S E R V I C E N O T E

1662EP - 68 Channel Color Logic Analyzer with 32 Channel Pattern Generator

New Threshold Accuracy Field Calibration Procedure

Page 2 Service Note 1662EP-01

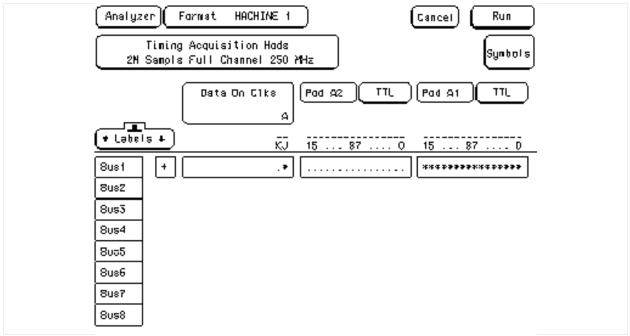
ADD the following steps to "Set up the logic analyzer" on page 3-10 of the 1660E,ES,EP-Series service manual:

3 Set up the Format menu.

- a. Press the Format key.
- b. Move the cursor over the Pod A1 channel selection field.

Press the Clear Entry button until all channels are assigned (all '*'), then press Done.
- c. Move the cursor over the Data on Clocks channel selection field, then press Select. Rotate the RPG knob to move the channel selector to the channel indicated in the following table, then press Select. Press Done.

4 Set up the Waveform menu.

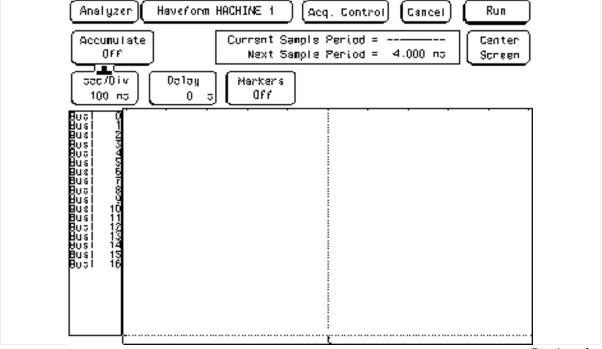
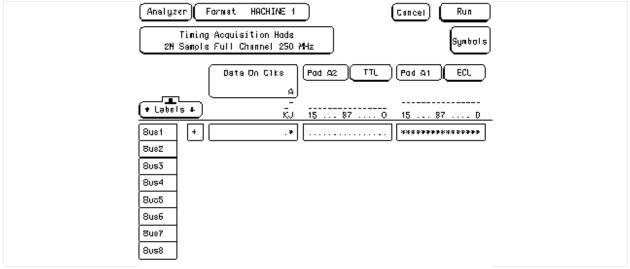
- a. Press the Waveform key.
- b. In the Waveform menu, move the cursor to the pod/channel selection field, then press Select.

In the pop-up menu, select Delete All, then select Continue.

c. Again press Select. At the pop-up menu, select Insert, then select Bus1, then select Sequential.

2 Test the high-to-low transition.

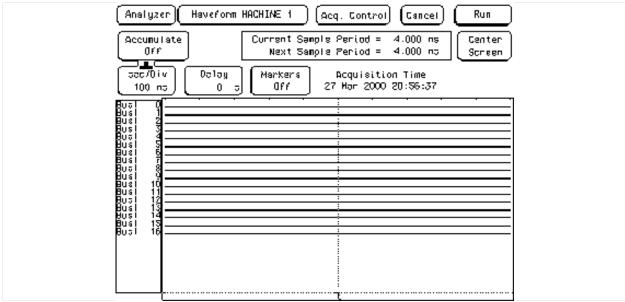
REPLACE pages 3-11 thru 3-17 with the following steps:

- a. On the DC power source, enter -1.438 V.
- b. On the multimeter, verify that the DC voltage is -1.439 V +0 mV, or -2 mV. Adjust the DC power source voltage output if necessary.
- c. On the logic analyzer, press Run. The display should show all channels at a logic "0".
